Recall Bulletin

PRODUCT SAFETY RECALL

SUBJECT: Safety Belt Lap Anchor Tensioner Cable

MODELS: 2011-2012 Chevrolet Malibu

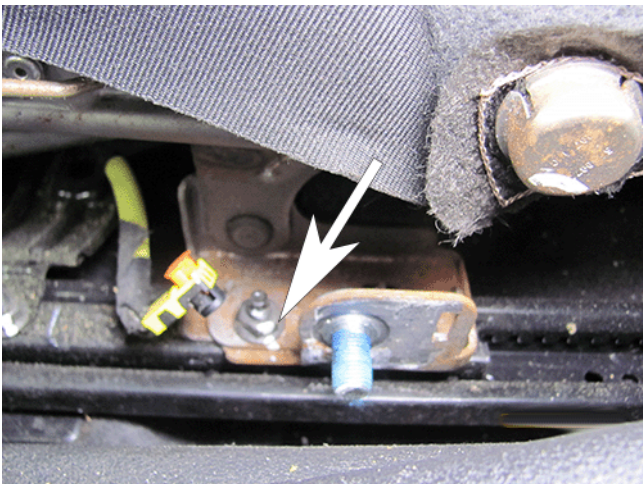
3. If a sleeve is cut or cracked on the cable (1) or where the cable meets the buckle (2), replace the front seat belt anchor plate tensioner in step #10.
4. Remove the front seat belt anchor plate tensioner. Refer to *Front Seat Belt Anchor Plate Tensioner Replacement* in SI. If the shrink sleeve does not show any damage, it is not necessary to disconnect the anchor plate from the belt.

10. Reinstall the seat belt anchor plate tensioner. If the shrink sleeve was found to be damaged in step #2 above, replace the affected front seat belt anchor plate tensioner. Refer to *Front Seat Belt Anchor Plate Tensioner Replacement* in SI.

4292763

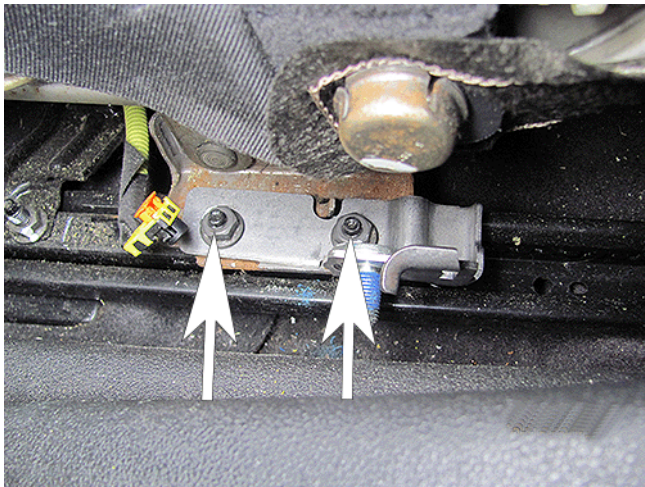
- 7. Remove and discard the old mounting bracket.
- 8. Install the new mounting bracket, note there are left hand and right hand brackets. Insure the correct bracket is installed.

Note: Ensure the seat belt buckle cable is routed **BEHIND THE TAB** on the replacement mounting bracket.

- 9. Install two new fasteners, **Tighten 19-25 N.m (14-18 lb. ft.)**
